ROOSEVELT APARTMENTS

DPD Project #3021266

Recommendation Meeting
Northeast Design Review Board

January 30, 2017

ALLEY ELEVATION RENDERING

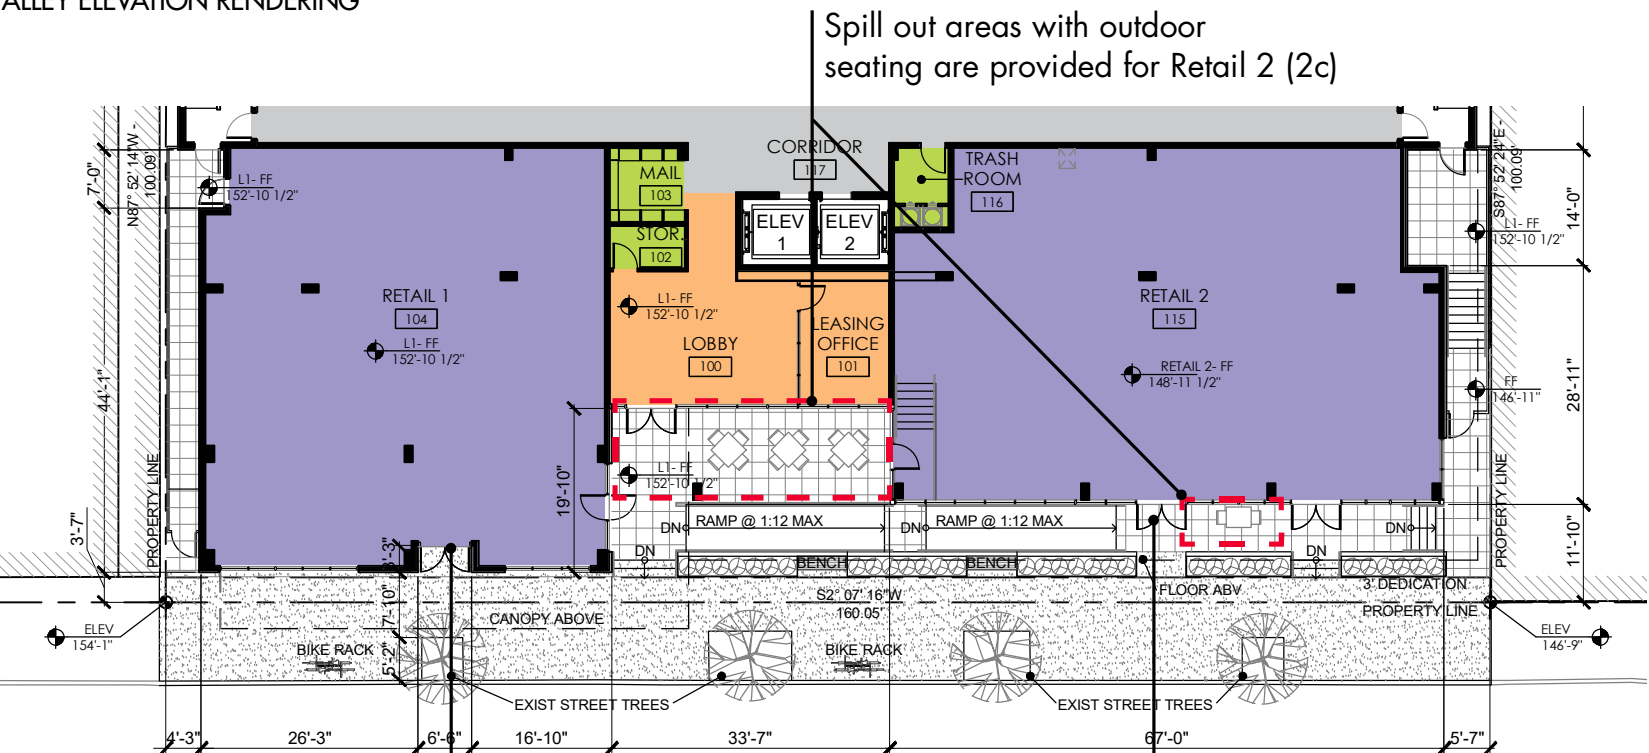
b. Ground-level retail spaces should stay with grade, or be slightly above, to provide adequate width and height at grade to achieve a comfortable pedestrian experience. If any portion of the sidewalk must be sunken due to the grade of the retail, it should be as minimal as possible. No entry should be located below grade. The Board indicated they may be open to a departure to allow less than a 13’ height for retail to avoid sunken entries or sidewalks. (CS2-A, PL1-B, PL3-C, PL3-II, C2-A, DC3-A, DC3-B)

RESPONSE: The building design has been developed to incorporate a retail sidewalk that will stay close to grade with no portion located more than 30” above the existing sidewalk so that guardrails will not be required, which would restrict views in and out of the retail developments. The retail and lobby spaces will be at two different heights, but no area will have less than 13’ floor to floor, in order to meet code and no spaces will be sunken at any area. All spaces will be ADA compliant.

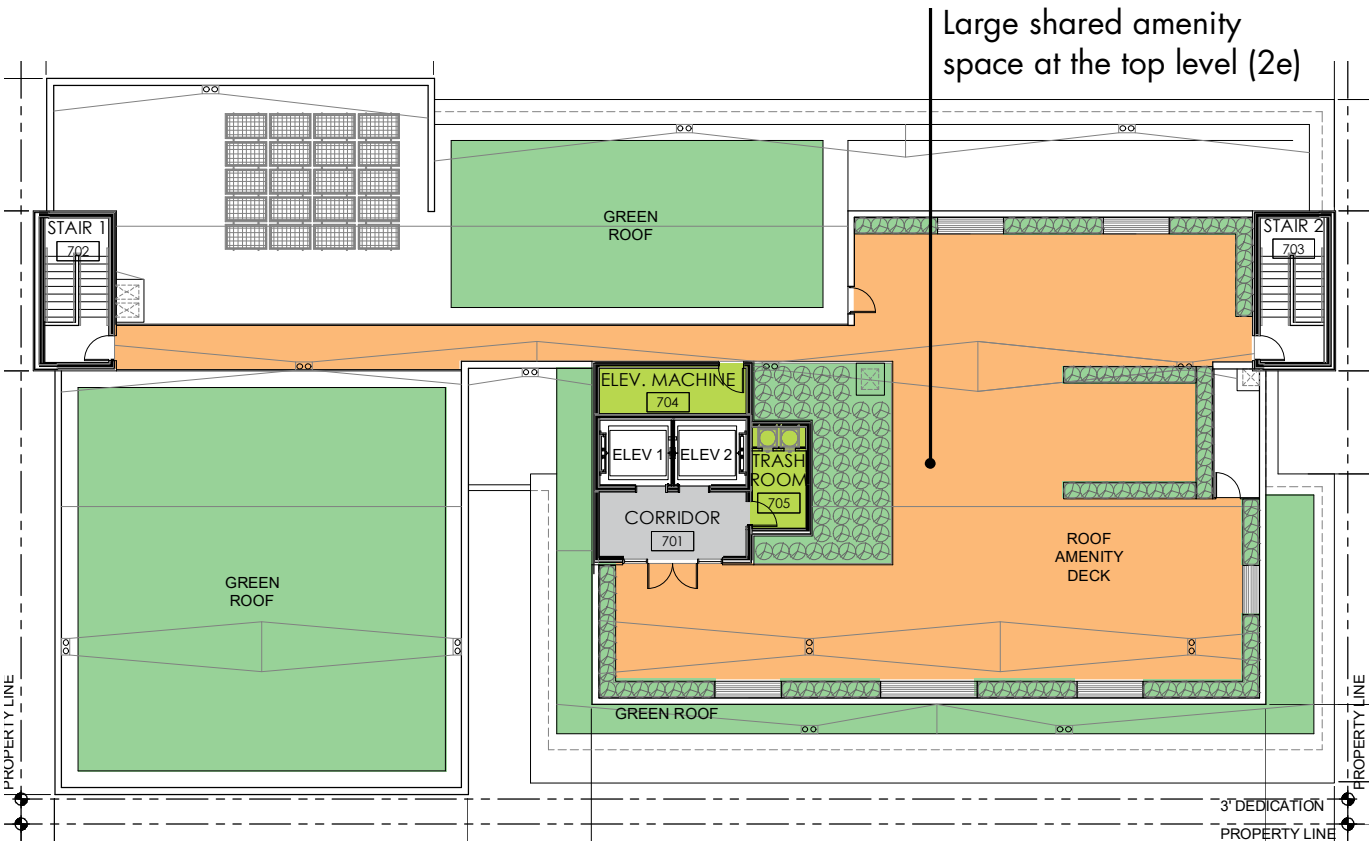
a. The entry court should be located at or above grade. The Board suggested that the space could spill into the raised area created by the plinth wall along the sidewalk. (DC3-A, DC3-I)

RESPONSE: The entry plaza is located above grade per the Board’s recommendation.
